Rezoning Transportation Analysis

Petition Number 2016-089 **Updated** 6/24/2016

Location Approximately 4.35 acres located on the south side of DeArmon Road between Mineral Ridge Way and Hampton Place Drive.

A9	DeArmon Road (West of Clark's Creek)											
	6'	8'	n/a	5'	11'	11'	5'	n/a	8'	6'

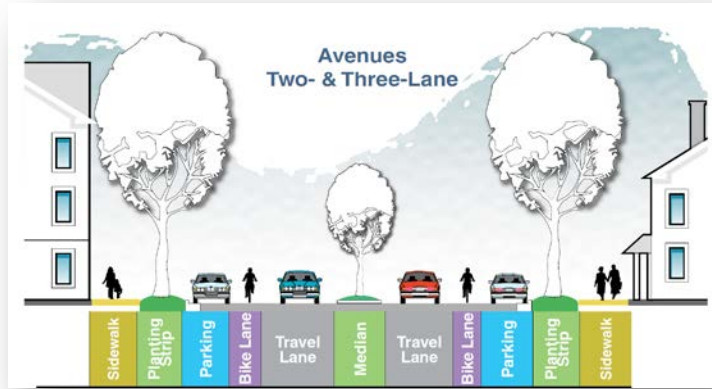
1. CDOT recommends coordination with Kristie Kennedy (Engineering Property Management, 704.336.6194) to confirm or correct the cross section in the Prosperity Hucks Area Plan (see below) to conform to the City’s Farm to Market upgrade project.

- The petitioner should revise the site plan to identify and construct the pavement, curb line, planting strip and sidewalk in accordance with the City’s future plan along the site frontage along DeArmon Road. Per the Prosperity Hucks Area Plan (see below) the site plan should show curb and gutter 24’ from existing centerline. After meeting with City staff, DeArmon Road widening and street streetscape improvements will be implemented by the City.
